1 Products affected

2 Type of change

Product Change Notification					PCN DFKH-22 Terminal pins changed		
owner	creation date	release date	released by	change order	rev	page	D10-080-722
segatro	15.01.2024	18.03.2024	blumhe	2027294	A	1 of 1

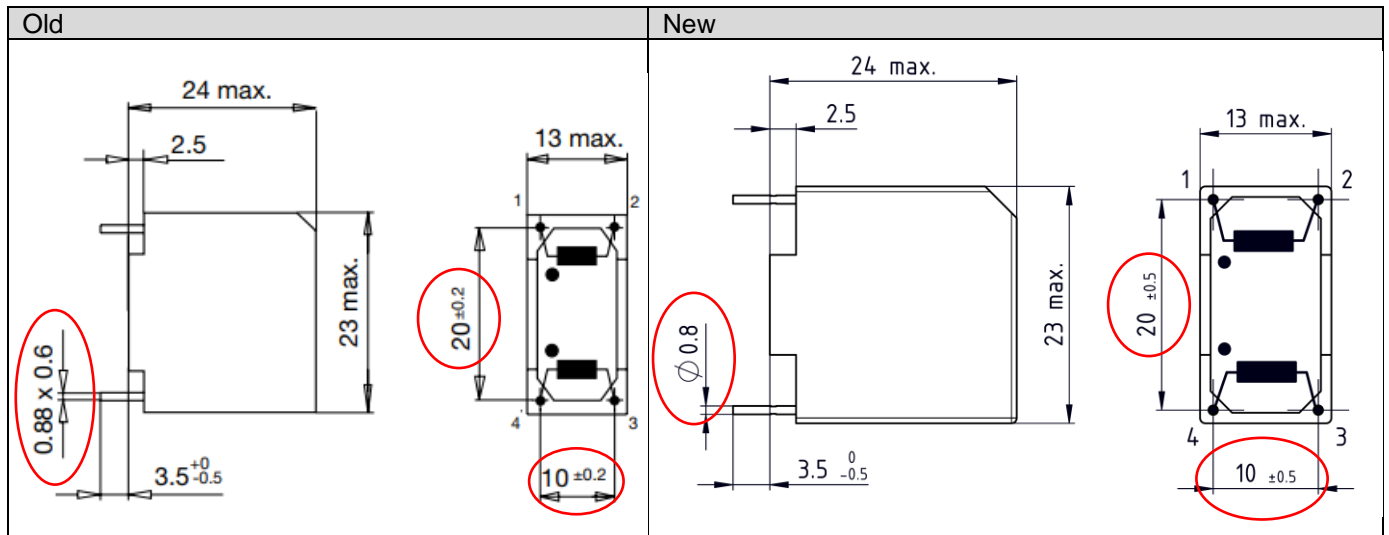
- Terminal pins changed

- Rectangular pins substituted with round pins

- Standardization of choke cases
- Optimize assembly process

Form	Yes	Check PCB pin hole dimension and tolerances
Fit	No	-
Function	No	-
Manufacturing	No	-
Label	No	-
Packaging	No	-
